**Notice of Specification Changes for Mitsubishi Energy Measuring Unit
EcoMonitorLight and EcoMonitorPlus due to revisions to UL Standards**

We would like to inform you that, in accordance with revisions to UL standards, we will be making the following changes to the Mitsubishi Energy Measuring Unit EcoMonitorLight and EcoMonitorPlus to ensure continued compliance with the standards.

■ In the case of EcoMonitorLight

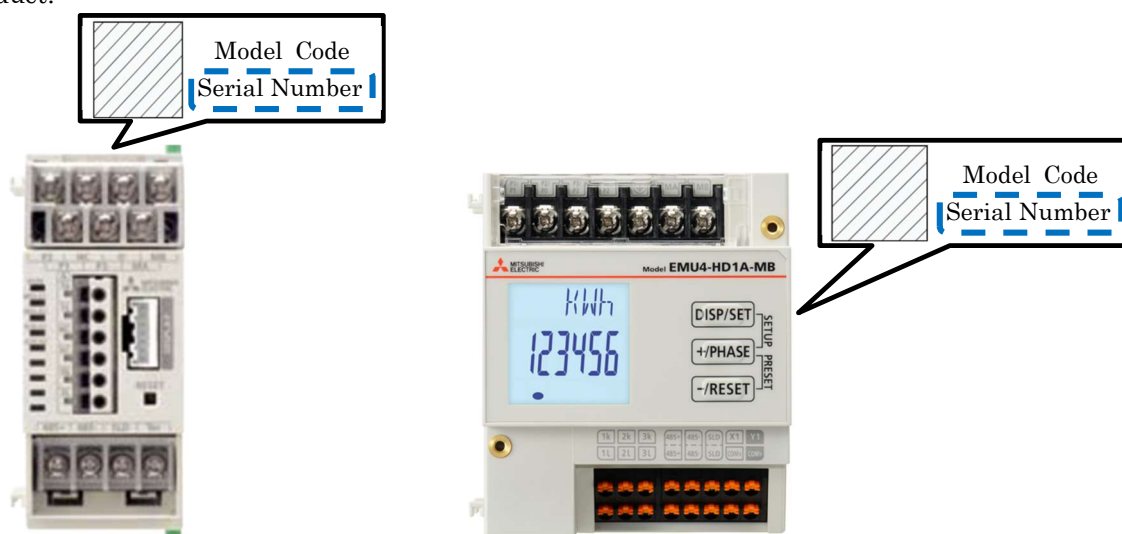
Please note that systems combining **pre-revised models*** (manufactured before August 2026) with **revised models*** (manufactured in or after August 2026) are **not compliant with UL standards**. For further details, please contact your local distributor or representative.

UL standards	Current sensor	Optional Unit	Energy Measuring Unit
Compliance	Products manufactured <u>Before</u> August 2026	Products manufactured <u>Before</u> August 2026	Products manufactured <u>Before</u> August 2026
Compliance	Products manufactured <u>from August 2026 onwards</u>	Products manufactured <u>from August 2026 onwards</u>	Products manufactured <u>from August 2026 onwards</u>
Non-Compliance	Combinations of products manufactured <u>Before/After</u> August 2026

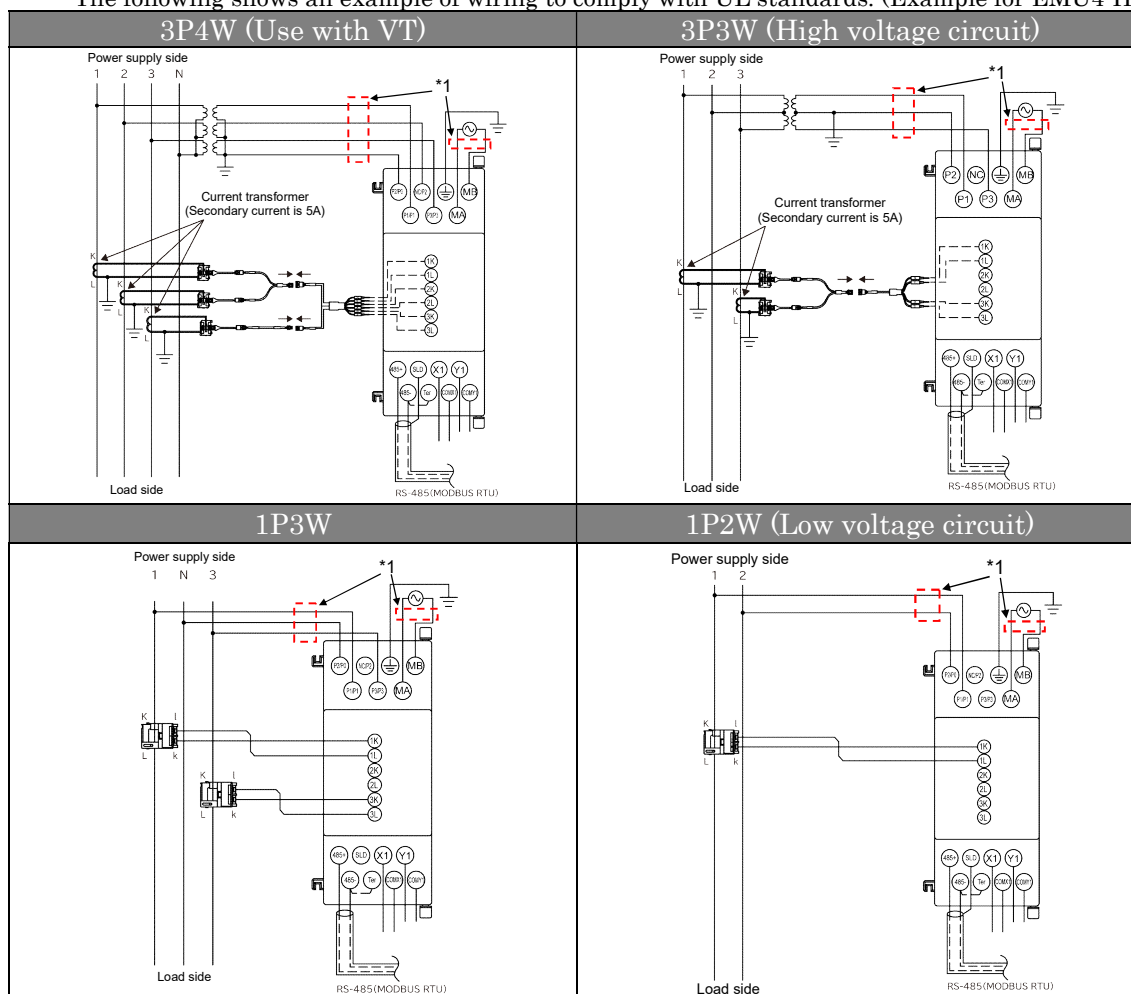
(1) Voltage Input Terminals and Auxiliary Power Terminals: Addition of overcurrent protection devices
When using this device as a product compliant with UL standards in North America, an overcurrent protection device must be provided.

The following shows an example of wiring to comply with UL standards. (Example for EMU4-HM1-MB)

*1: The following shows the recommended specifications for overcurrent protection devices based on the evaluation conditions at the time of UL certification.

■ For circuits other than branch circuits: Fuse

- Rated current: 0.5 A
- Breaking capacity: 250 V AC 1,500 A / 250 V DC 1,500 A
- UL certified

■ For branch circuits: Fuse or circuit-breaker (for branch circuit protection)

- Rated current: 1.0 A
- Rated voltage: Equal to or higher than the circuit voltage to be used
- UL certified

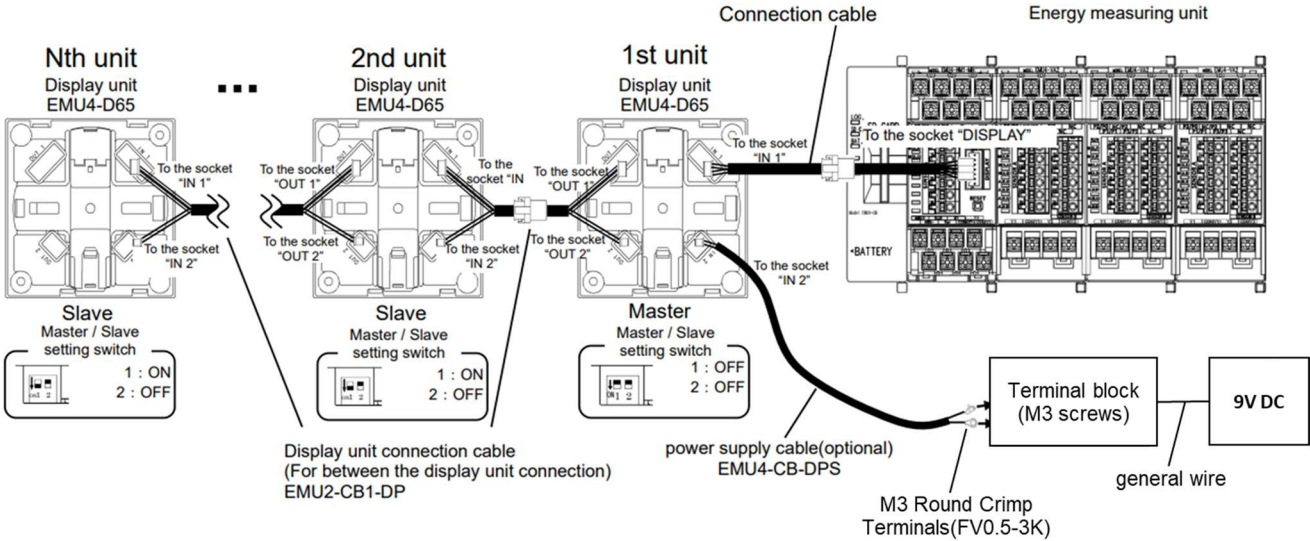
When using EMU4-D65 display units as a product compliant with UL standards in North America, the external DC power supply (9 V) used for connecting two or more units must be changed. Additionally, an intermediate terminal block (M3 screws) must be installed for the connection.

If connecting two or more display units to a single energy measuring unit, please connect them as follows.

Item	Before	After
Model	PBA15F-9	AJM-24S09
Manufacturer	COSEL Co., Ltd.	MINMAX Technology Co., Ltd
Output Voltage	9V DC	9V DC
Input Voltage Range	85 to 264V AC	85 to 264V AC

- *If UL compliance is required, please use the following recommended terminal blocks and general wires.
- | | |

| [Recommended Terminal Blocks Specifications] | [Recommended General Wire Specifications] |
| •Voltage rating:300V | UL AWM Style 2405 |
| •Current rating:10A | •Voltage rating:300V |
| •Flame-retardant rating: V-0 or higher (UL-certified) | •Temperature rating:80℃ |
| | •Wire gauge: AWG 22 to 16 |
